ADDENDUM

Date Issued:	August 25, 2023
Project:	Intermountain Healthcare IMC- Angio Lab #3 Remodel 5121 South Cottonwood Street Murray, Utah 84107
Addendum Number:	1

Electrical Addendum

A113B

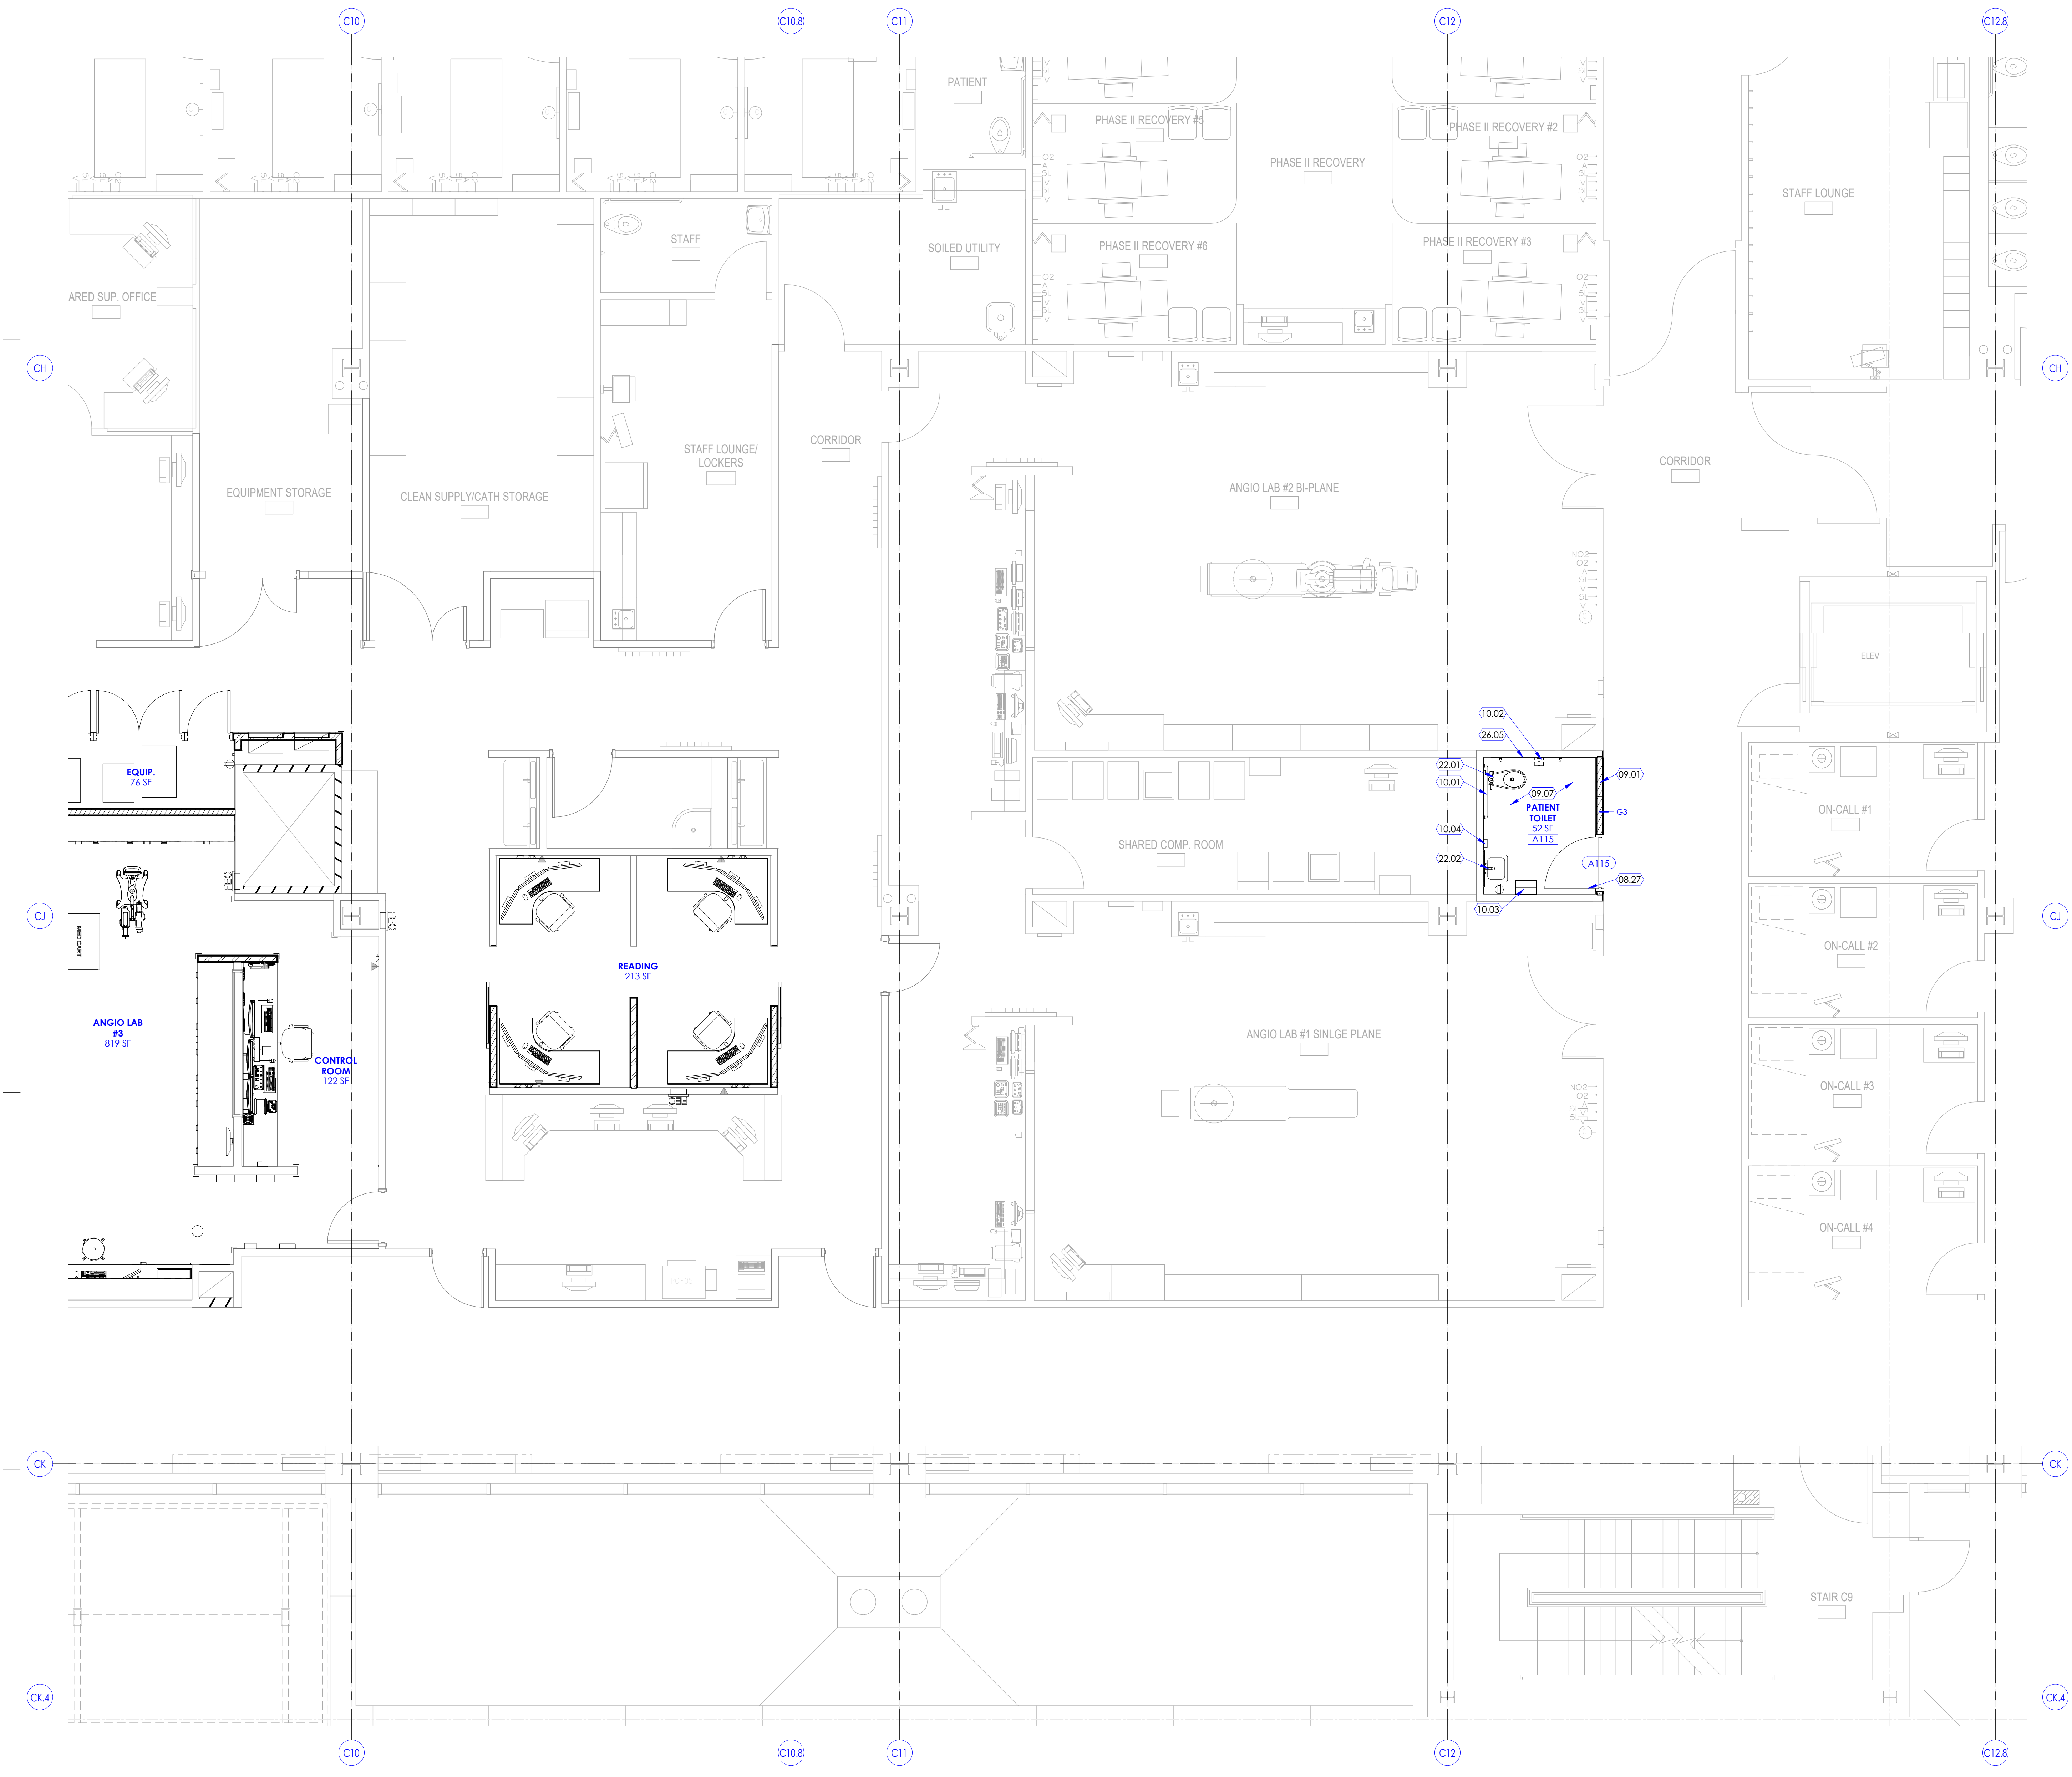
Sheet Number	Drawings
Architectural Drawings	
A103	See attached revised sheet with revisions shown clouded.
A113B	See attached revised sheet with revisions shown clouded.
A401	See attached revised sheet with revisions shown clouded.
A505C	See attached revised sheet with revisions shown clouded.
A601	See attached revised sheet with revisions shown clouded.
Q106	See attached revised sheet with revisions shown clouded.
Electrical Drawings	
ED101	See attached revised sheet with revisions shown clouded.
EP701	See attached revised sheet with revisions shown clouded.
EP702	See attached revised sheet with revisions shown clouded.
EP703	See attached revised sheet with revisions shown clouded.
EP704	See attached revised sheet with revisions shown clouded.
EY101	See attached revised sheet with revisions shown clouded.

ED101

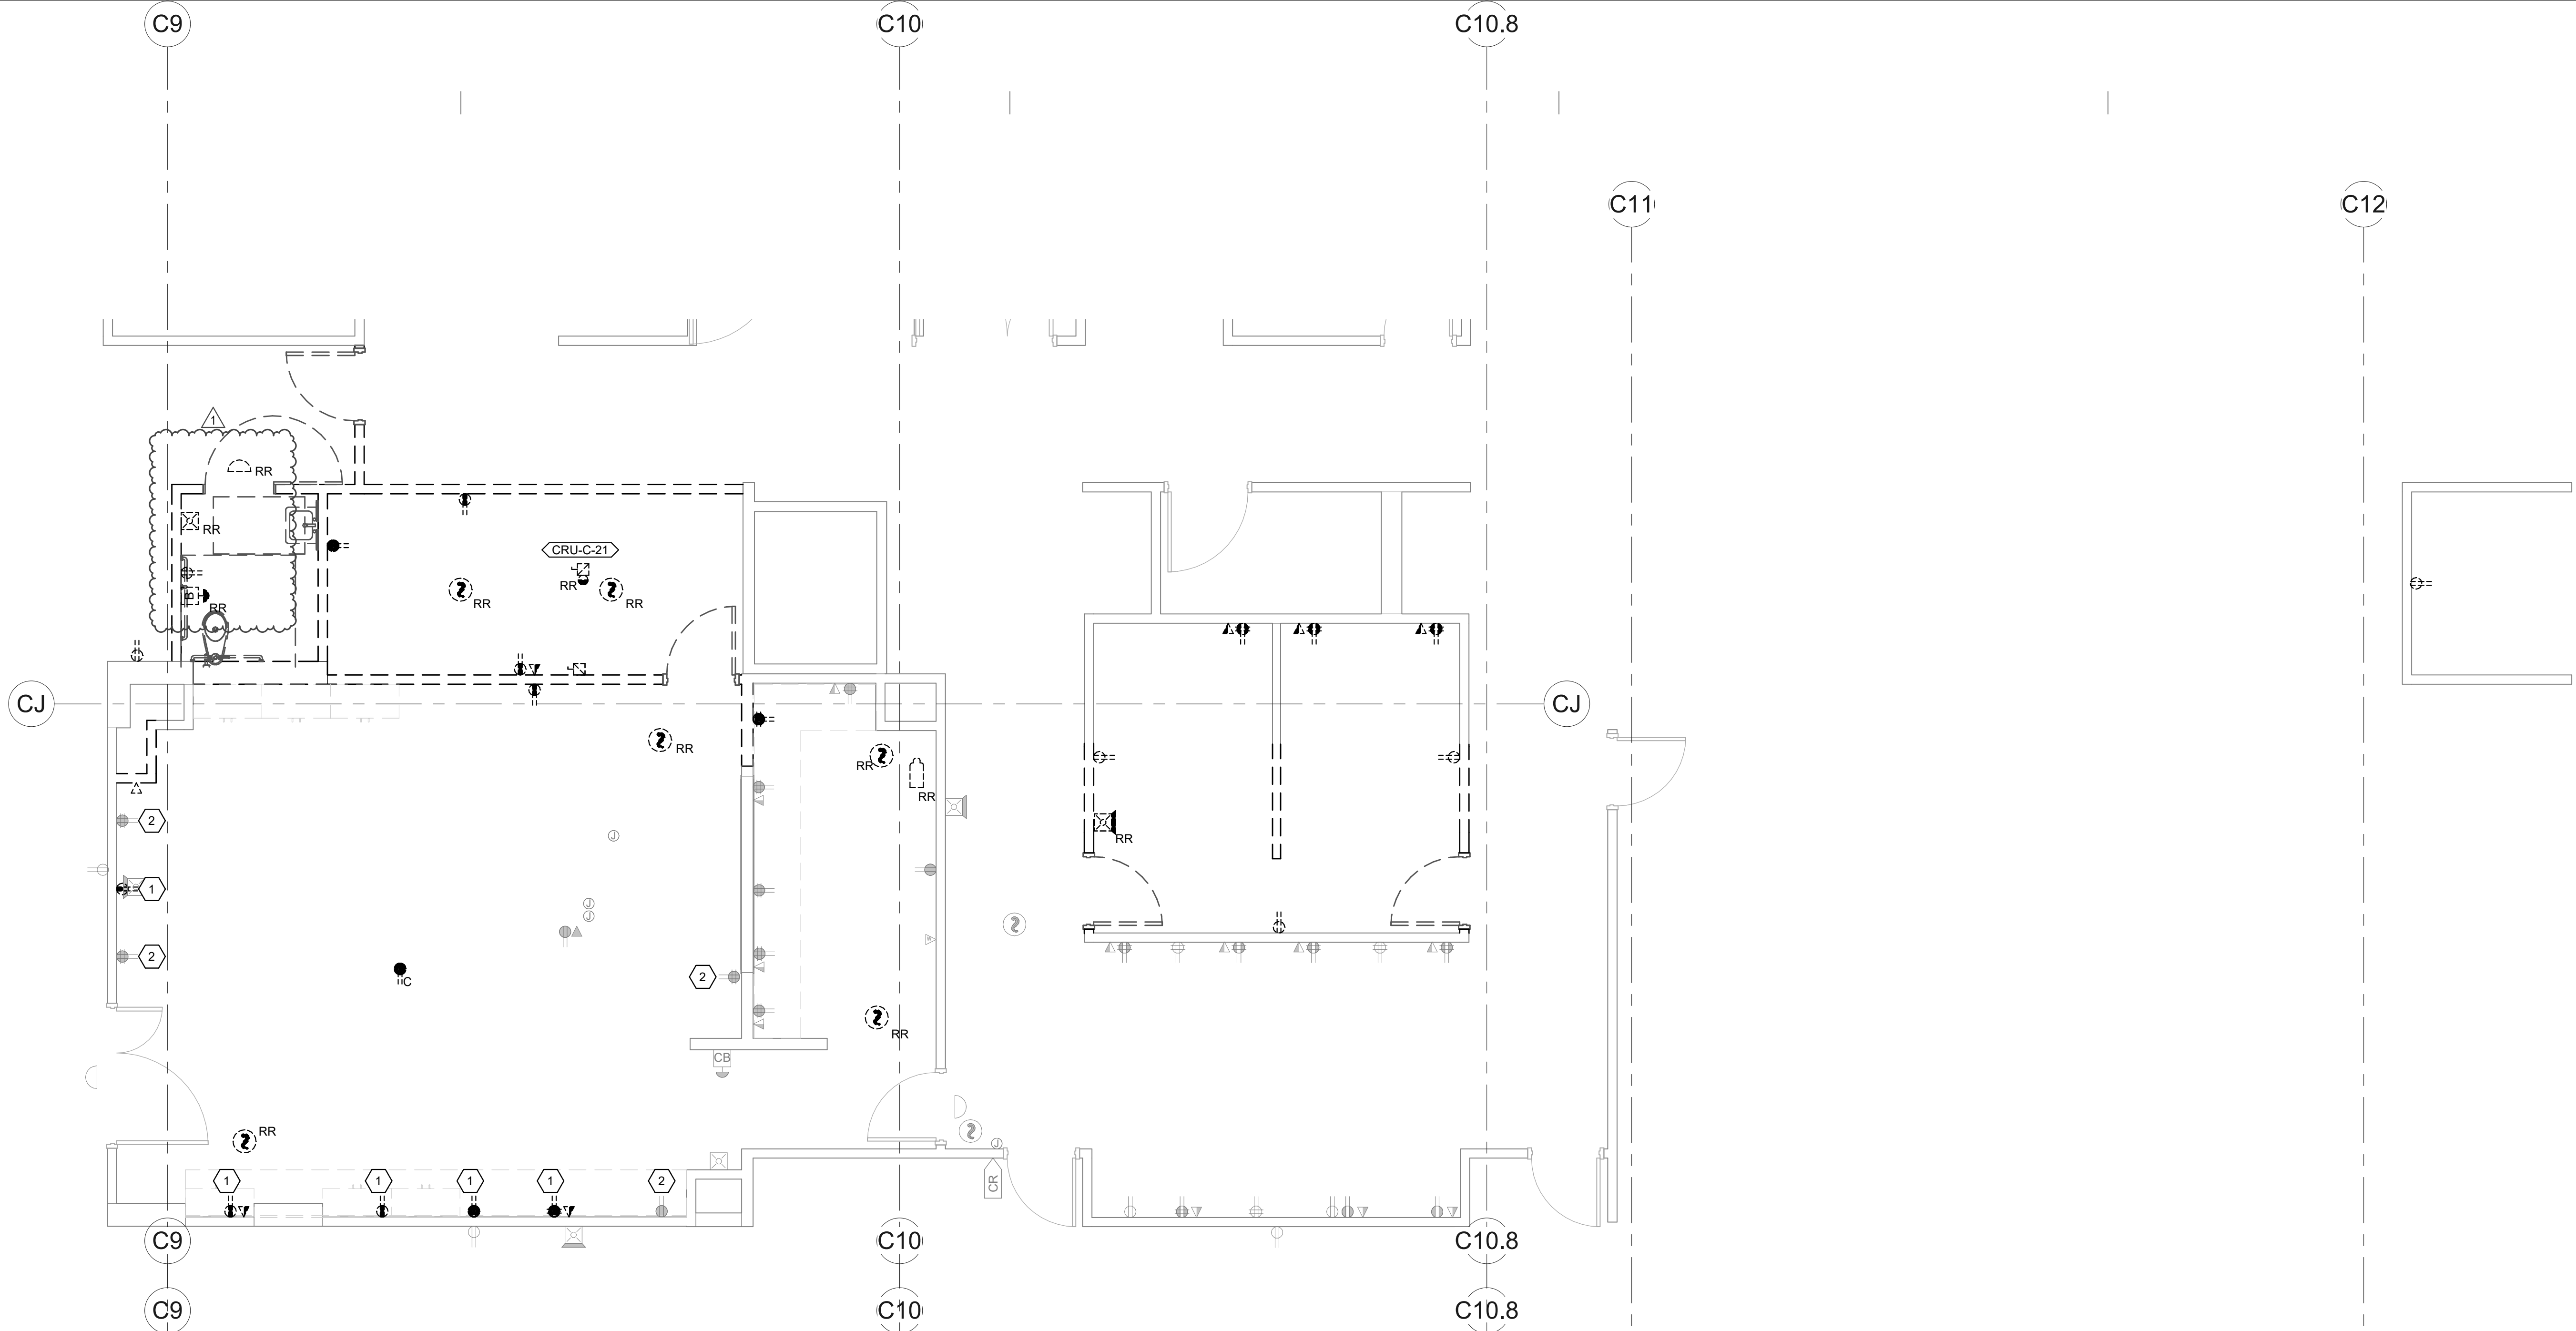
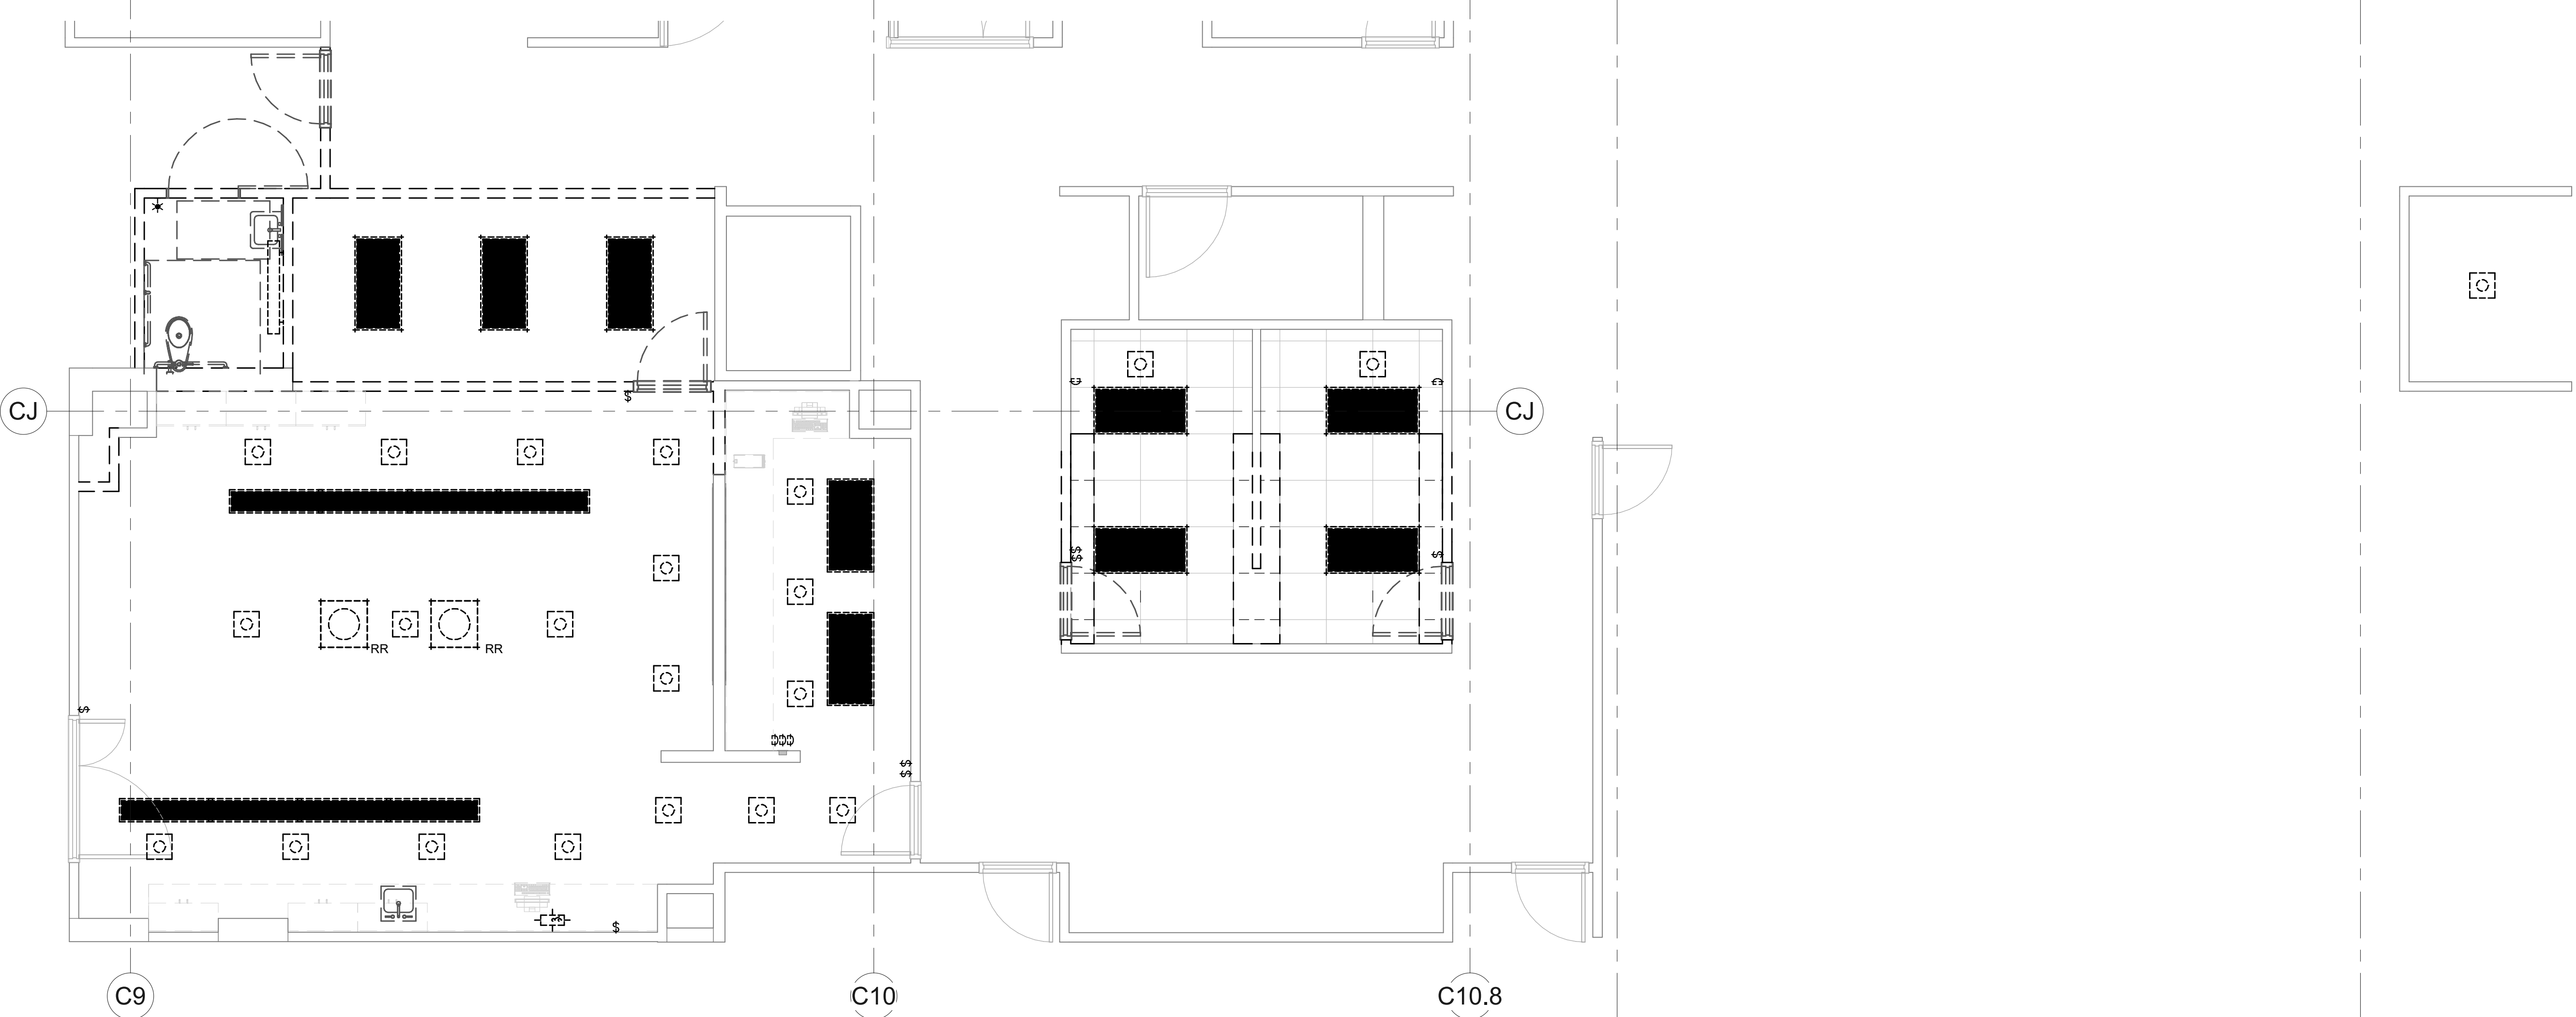
1. ED101 – Level 1 Electrical Demolition Plan
 - a. Showed nurse call pull station and dome light being relocated.
2. EP701 – Phillips Drawings
 - a. Updated to the latest Phillips drawings revision.
3. EP702 – Phillips Drawings
 - a. Updated to the latest Phillips drawings revision.
4. EP703 – Phillips Drawings
 - a. Updated to the latest Phillips drawings revision.
5. EP704 – Phillips Drawings
 - a. Updated to the latest Phillips drawings revision.
6. EY101 – Level Auxiliary Plan
 - a. Added relocated nurse call pull station and dome light to new restroom.
